ARC #1 - MAY 29, 2019
ARC #2 - FEBRUARY 12, 2020
BOARD BRIEFING - AUGUST 5, 2020

GRAND CENTRAL BLOCK

200 S 1ST ST, Seattle, WA 98104

"What We Heard" - ARC #1 & #2

PENTHOUSE VIEW STUDY

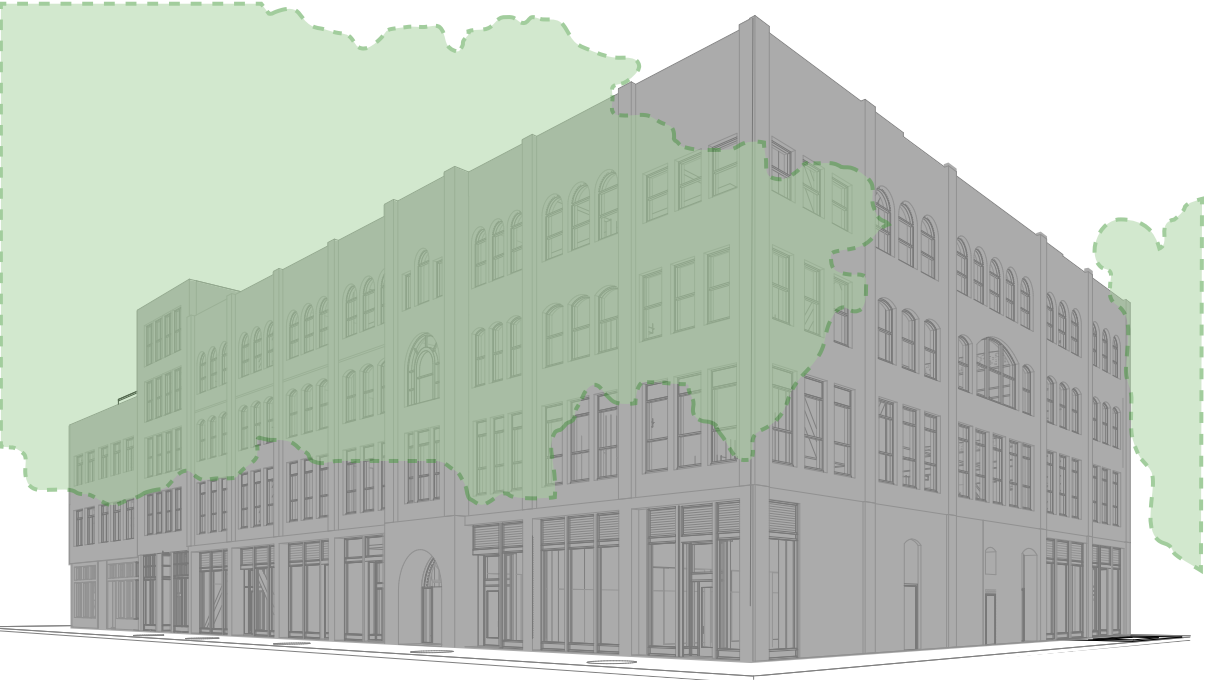
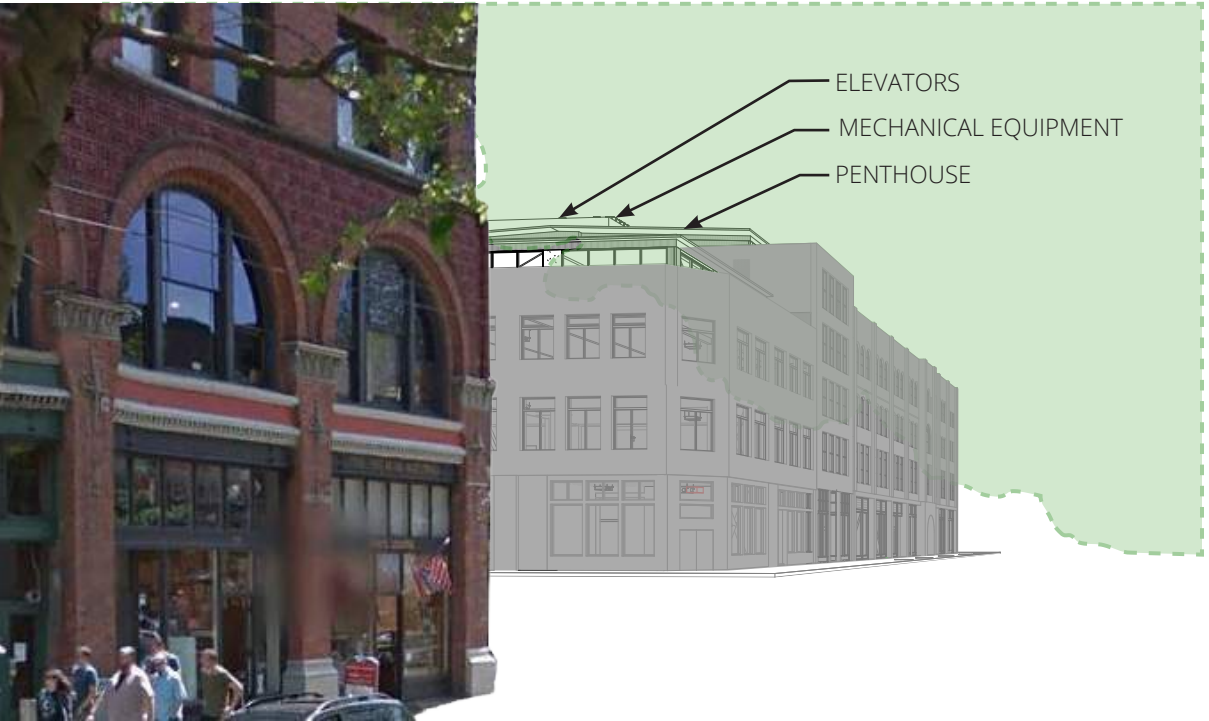
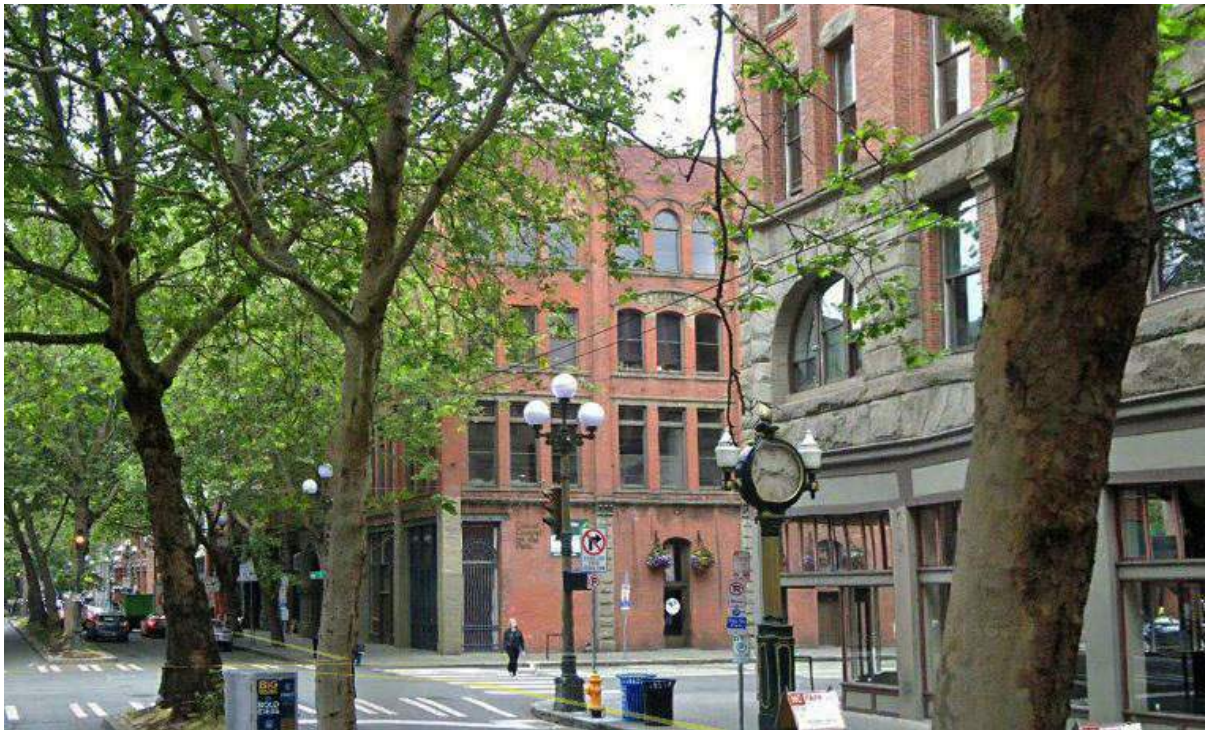
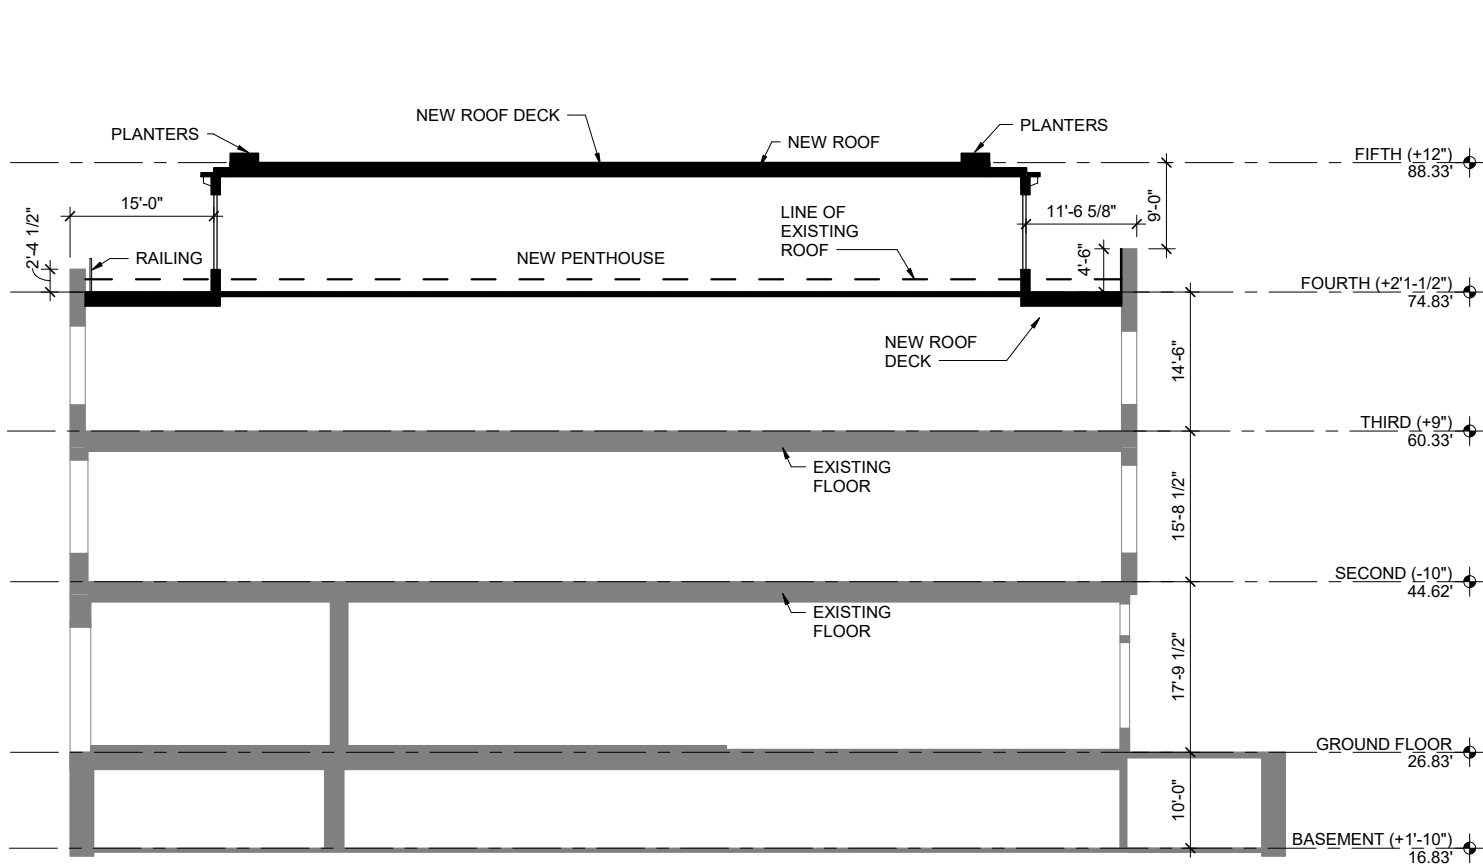
- Provide additional information on where the views for the penthouse renderings are located.
The locations of the renderings are identified on the site plan and on key plans in the FACADES section. Photos showing existing view from the spot the renderings are taken have been added to the rendering sheets in the PENTHOUSES section.

PENTHOUSE SECTIONS

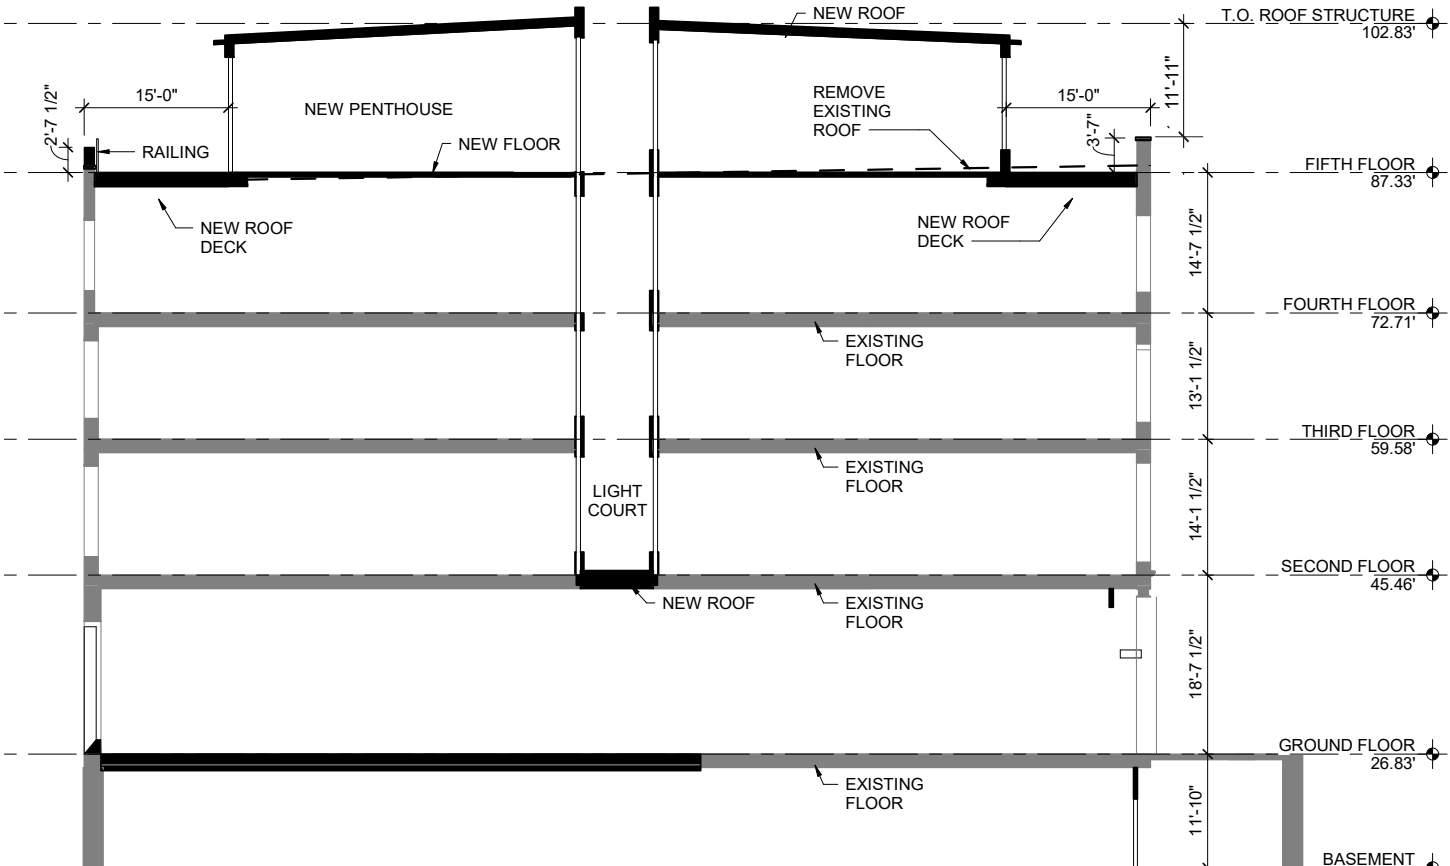
- Penthouse height is set based on the height of the parapet, not the existing roof.
The penthouse height has been revised and dimensioned based on the parapet heights. See sections in the PENTHOUSES section.

SMC 23.66.140.C.4.f
The office penthouses is located within 12' of the top of the existing parapet.

Parapets are lower at alley elevation. Where the parapet is lower than 42", a railing will be provided for fall protection.

ENLARGED ELEVATION - REVISED MASONRY OPENING

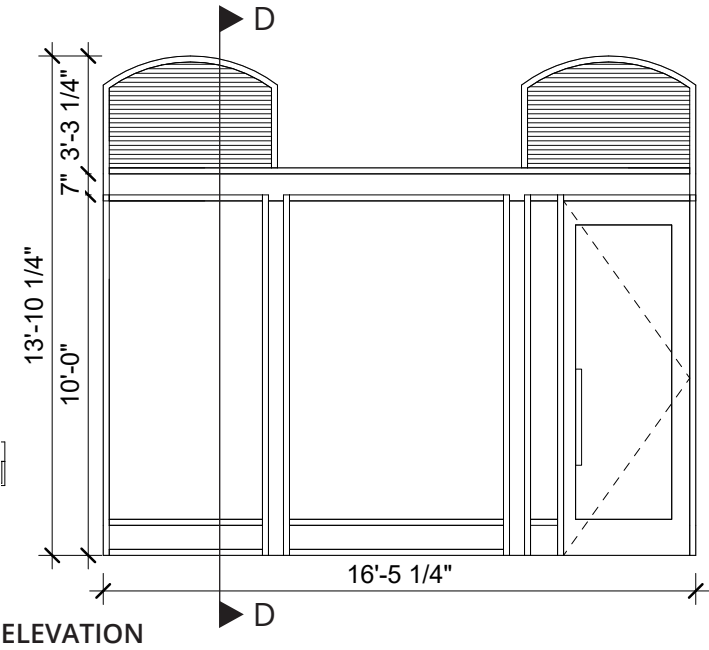
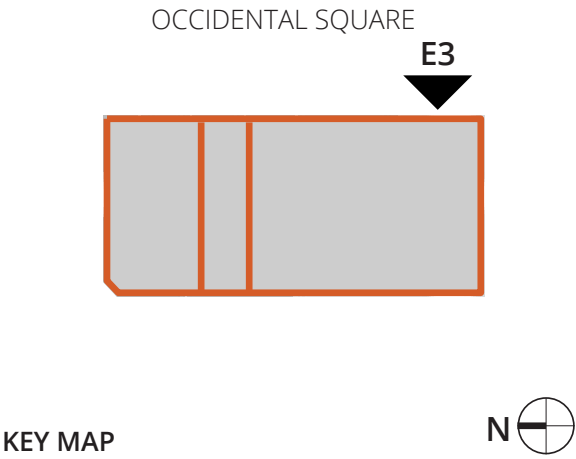
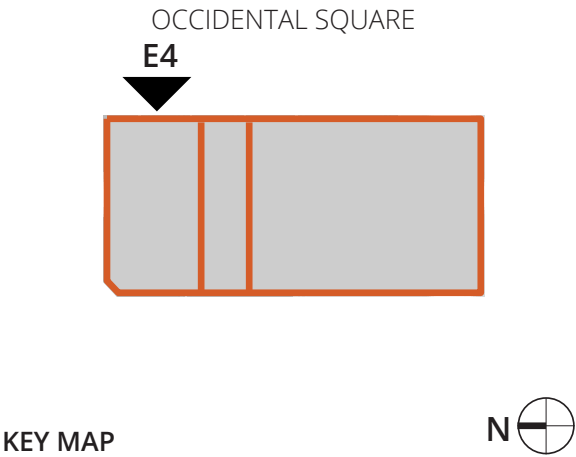
- Provide additional information on the new glass storefront areas. What URM is being removed? What is the condition of the URM proposed for removal? Why is the URM being removed?
The sections of URM on the Alley facade are being removed to improve connections between the retail/restaurant tenants and the park. The amount of URM being removed has been significantly reduced. Material is only being removed at 2 locations. Photos indicating location of removal and condition can be found in the ALLEY section.

- Will the arches be preserved wher the masonry is being removed?
Yes. Arches will be preserved and visible.
- Provide additional studies of the entries, including any awnings and canopies.
The design no longer includes canopies. Awnings may be added by individual tenants at a later date, but are not part of the core and shell application. Studies of each primary entry are included in the FACADES section.

EXISTING MASONRY
TO BE REMOVED

EXISTING MASONRY
AND OPENINGS TO
BE REMOVED

FIRE ESCAPE

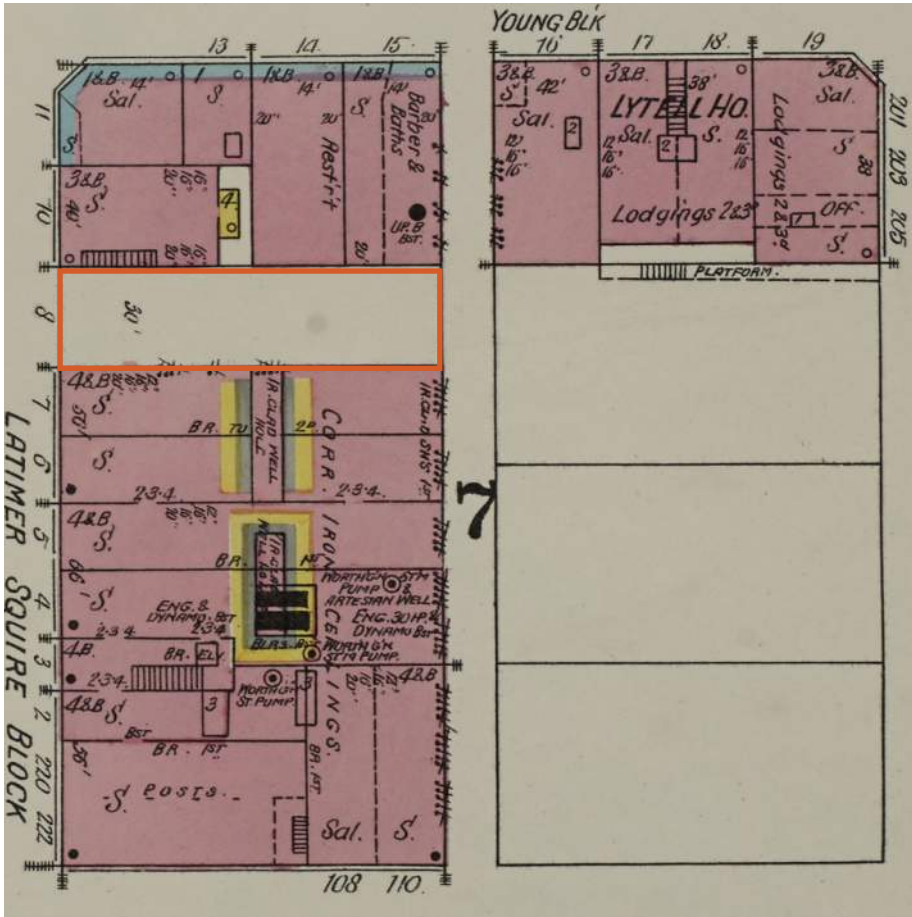
- Provide a history of the fire escape.
Refer to the FIRE ESCAPE section.

- The owner requests removal of the fire escape for safety.

- The alley is now a more visible building facade.
- Decommissioned fire escapes are a safety hazard due to climbing.
- Decommissioned fire escapes are onerous to maintain.

- 1893 - No escapes noted at alley.
- 1903 - City Loan constructed - no drawings from construction
- 1904 - First record of fire escape in this location.
- 1972 - Fire escapes removed from Grand Central as part of renovation. Becomes park facing facade.
- 1974 - Fire escape modified to accomodate greenhouse
- 2002 - Fire escape decommissioned as part of renovation project. Buttnick fire escape removed.
